Project Number: 219061.00 (030)
Project Name: Gallery
Location: 3104-3127 North 71st Street
Scottsdale, Arizona 85251

Subject: Construction and Design Compliance Report

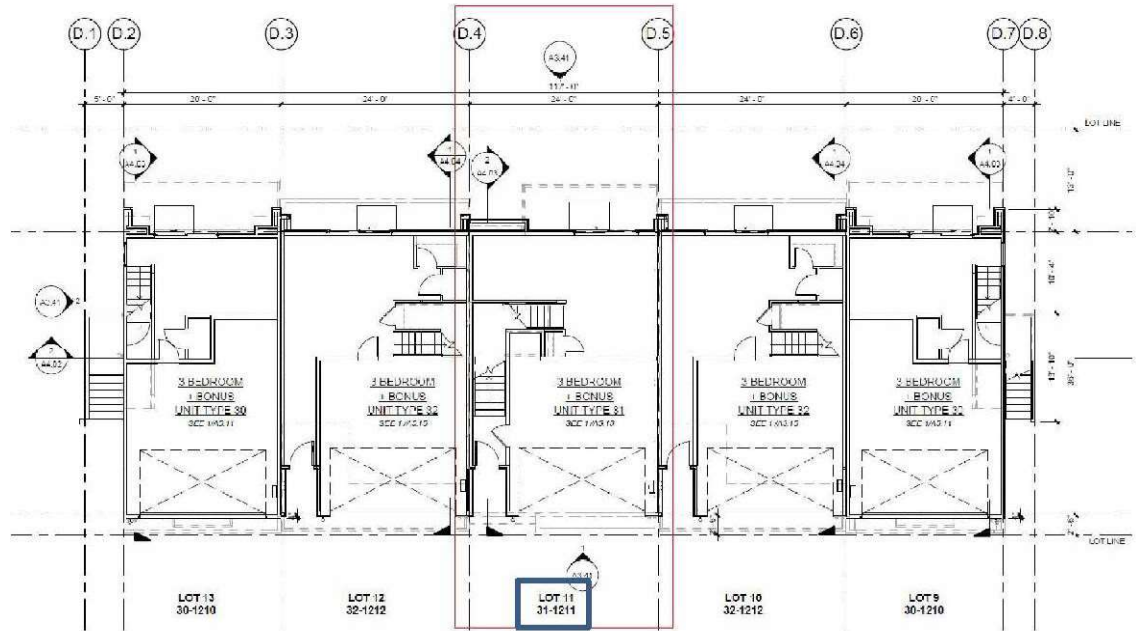
Intrusive examination revealed the framing at Unit 3111 of Building D of the Gallery site was constructed without the proper LFRS that was clearly detailed on structural braced/shear wall plans. The architectural plans label Building D as plan type 31-1211. The structural braced/shear wall plans for the front of the second floor of plan type 31-1211 specify a braced/shear wall type 4, which is a continuous 3/8-inch minimum rated sheathing behind the pop-out wall with .113 x 2-3/8-inch nails spaced per the braced/shear wall schedule. The braced/shear wall plan required one CMSTC16 or two CS16 straps at each end of the exterior sheathing installed with required fasteners to provide minimum tensile capacity of 3410-pounds-force.

As constructed, the cladding was installed over open stud framing without the required exterior sheathing at the second floor level between the triple panel slider window in the great room and the pop-out wall. Fasteners in the CS16 strap connecting the exterior sheathing below the triple panel window were missing and the steel strap had buckled. The buckled steel strap and the missing exterior wood sheathing failed to comply with the braced/shear wall plan specified on the structural drawings. The non-compliant condition more likely than not reduces the structural integrity of the LFRS, as intended by the Structural Engineer of Record (EOR) and requires repairs.

- Where exterior sheathing is identified as missing, install new 3/8-inch minimum-rated sheathing using specified nails spaced to provide minimum shear resistance of 306-plf per the braced/ shear wall schedule.

- Where existing strap is identified as installed incorrectly, remove and replace with new strap per the holddown schedule. Install according to the manufacturer's installation requirements.

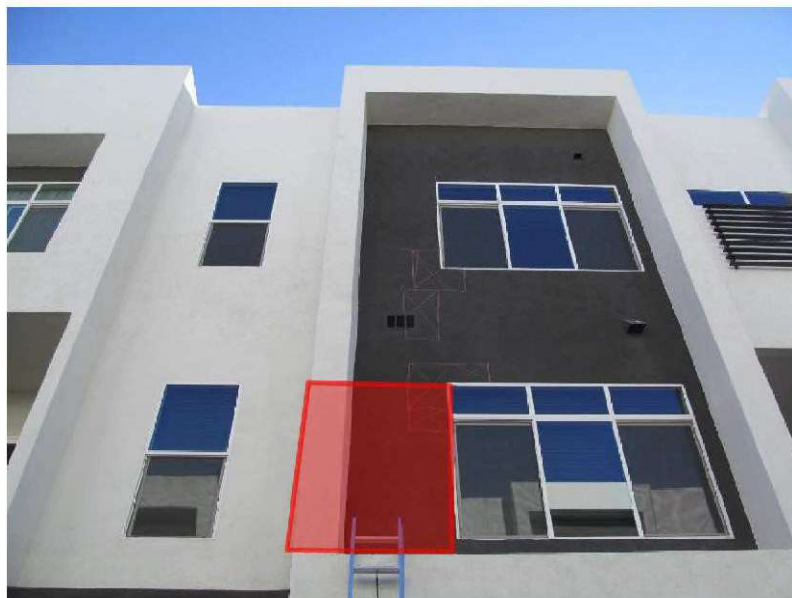
March 10, 2021, Disc IT8, Photograph 41, SSR, Building D – Unit 3111, overall view of building elevation with non-compliant LFRS. Red box outlines the approximate area within which the exterior sheathing was identified to be missing.

March 10, 2021, Disc IT8, Photograph 237, SSR, Building D – Unit 3111, missing OSB sheathing at existing stud framing.

March 10, 2021, Disc IT8, Photograph 248, SSR, Building D - Unit 3111, missing OSB sheathing at existing stud framing.

March 10, 2021, Disc IT8, Photograph 278, SSR, Building D - Unit 3111, CS-16 metal strap is disengaged and buckled.

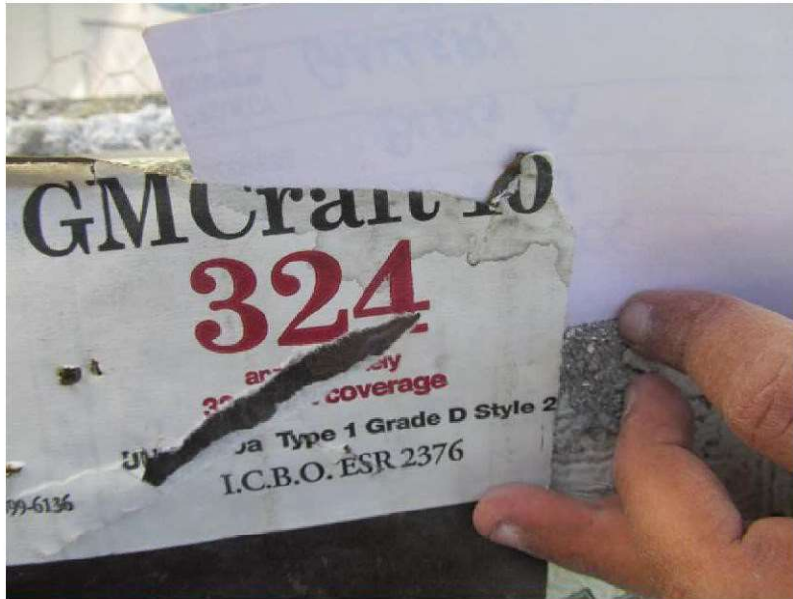
Intrusive examination revealed that a single layer of WRB was generally installed over open stud framing and solid sheathing. Occasionally, two layers of WRB over framing were identified to have been used. The WRB used at the Gallery site was labeled GMCraft-10 324, Type 1, Grade D, Style 2, ESR 2376. The label indicates that the WRB product used throughout the site is an asphalt-saturated type D building paper that has a nominal finish weight of 3.5-pounds-per-100-square-feet and designed to resist water intrusion for a minimum of 10-minutes when tested according to ASTM D-779. The nominal weight for a number 15 asphalt felt is generally between 7.5- to 12.5-pounds-per-100-square-feet (psf). The WRB manufacturer's product specifications state the GMCraft-10 exceeds 20-minutes of water resistance but does not meet the 60-minute requirement required by the building code and the stucco manufacturer. As constructed, the applied WRB does not meet the nominal weight, the number of required layers, the water resistance requirements of the applicable building code, and the ESR-3529 report for the Amerimix stucco system specified on the architectural drawings. This deficiency in material properties and number of WRB layers impairs the functionality of the stucco system as required in the building codes and the stucco manufacturer's product specifications.

- Full removal and replacement of the stucco and the exterior insulation is required to address the non-compliant installation of the WRB for the existing stucco system. Remove existing WRB to perform following repairs.

- Ensure that the WRB above is shingle-lapped with the sheet metal flashing.
- Install new WRB per the requirements of ESR-3529 for the existing stucco system.

- Repair contractor to estimate using between two layers of Grade D kraft building paper or one layer of Grade D kraft paper with minimum water-resistance rating of 60-minutes or using Tyvek products such as StuccoWrap or DrainWrap as specified in Section 3.2.4 and Section 3.2.10 of ESR-3529.

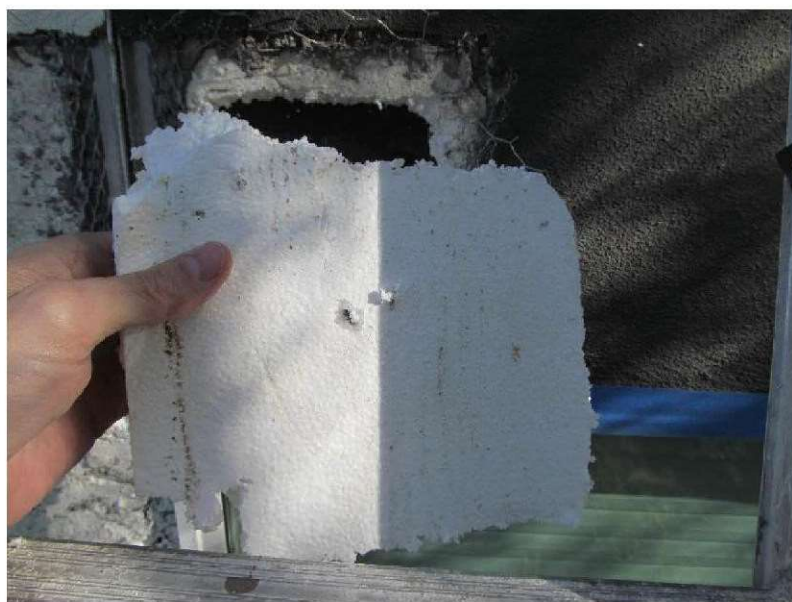
Intrusive examination revealed that the foam board used at the Gallery site was generally 3/8- to 7/8-inch thick, did not have the required vertical grooves, and was installed tight to the improperly selected WRB. The GMCraft-10 WRB was installed at all buildings and is not recognized by ESR-3529 for application of flat-faced foam boards without vertical grooves. Flat-faced foam boards installed tight to the WRB are non-compliant with the project requirements, prevent a bond break or drainage gap between the stucco system and the WRB, and obstruct drainage of the moisture behind the stucco. Use of non-compliant EPS foam boards in combination with the non-compliant WRB type reduces the overall performance of the moisture-management system. Damage included stains on the interior face of the EPS foam boards and full-length rusted fasteners where entrapped water overwhelmed the moisture-management system. This non-compliant condition, along with the combination of other construction defects of the stucco system, will more likely than not reduce the integrity of the structural components and the general appearance of the cladding in the foreseeable future.

- Ensure all EPS foam boards have 3/8-inch projecting tongues with compatible grooves at horizontal joints.
- At solid substrates, install new minimum 1/2-inch-thick EPS foam board with vertical grooves spaced at a maximum 12-inches on-center on the back face of the boards. The vertical grooves should be a minimum 1/4-inch wide by 1/8-inch deep as required by ESR-3529.

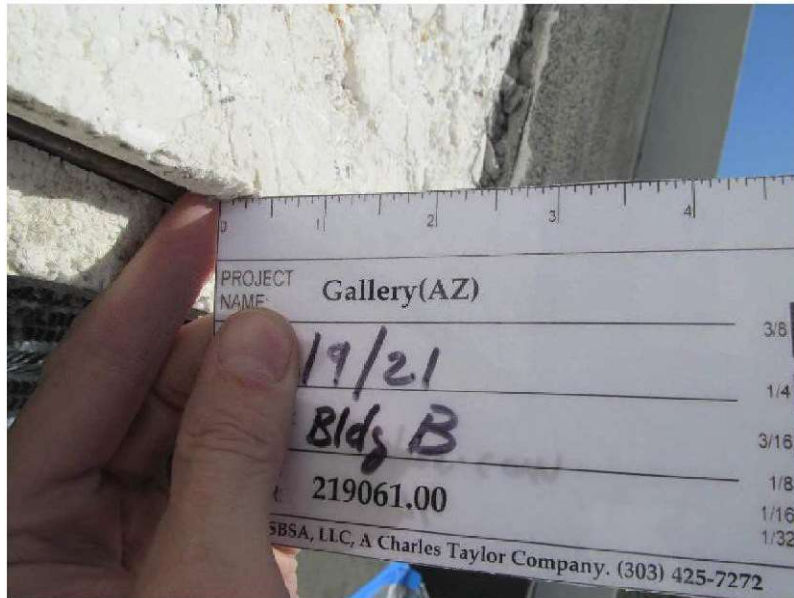
May 14, 2019, Disc IT3, Photograph 18, JBF, Building A, EPS foam board installed tight to WRB and vertical grooves generally missing at the inner face.

March 9, 2021, Disc IT6, Photograph 271, SSR, Building A, EPS foam board installed tight to GMCraft WRB and vertical grooves generally missing at the inner face.
